February 11, 2004

RE: Agenda for the March 9, 2004 Building Code Council Meeting

Table 502.2.3.3

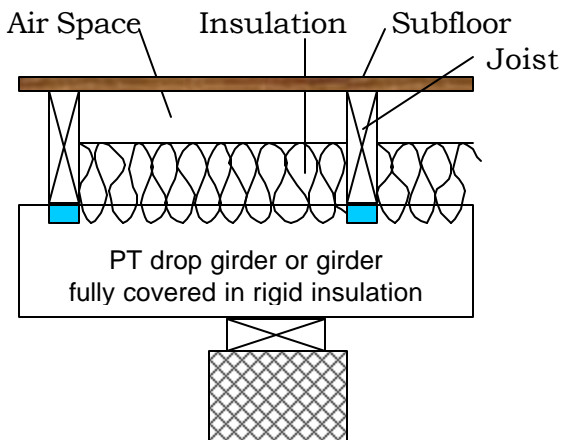
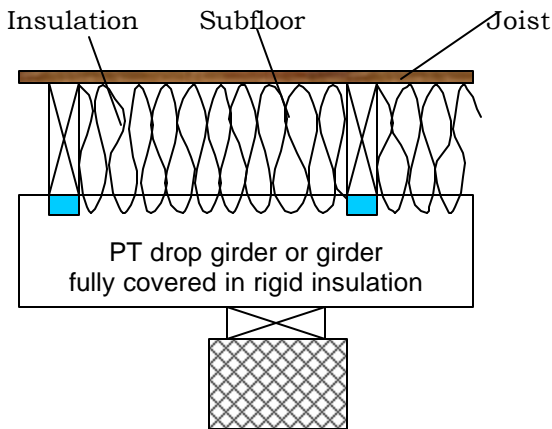
See suggested additions to table 502.2.3.3, below.

Table 502.2.3.3 FLOOR ASSEMBLIES (U_r selected shall not exceed the U_o specified in Section 502.2.3.3)		
R Value of Insulation	U_r	R_o
7	0.11	9.09
11	0.08	12.50
19	0.05	20.00
22	0.04	25.00
30	0.03	33.33

Table 502.2.3.3 FLOOR ASSEMBLIES (U_r selected shall not exceed the U_o specified in Section 502.2.3.3)		
R Value of Insulation	U_r	R_o
19	.05	20.00
22	.04	25.00
30	.03	33.33
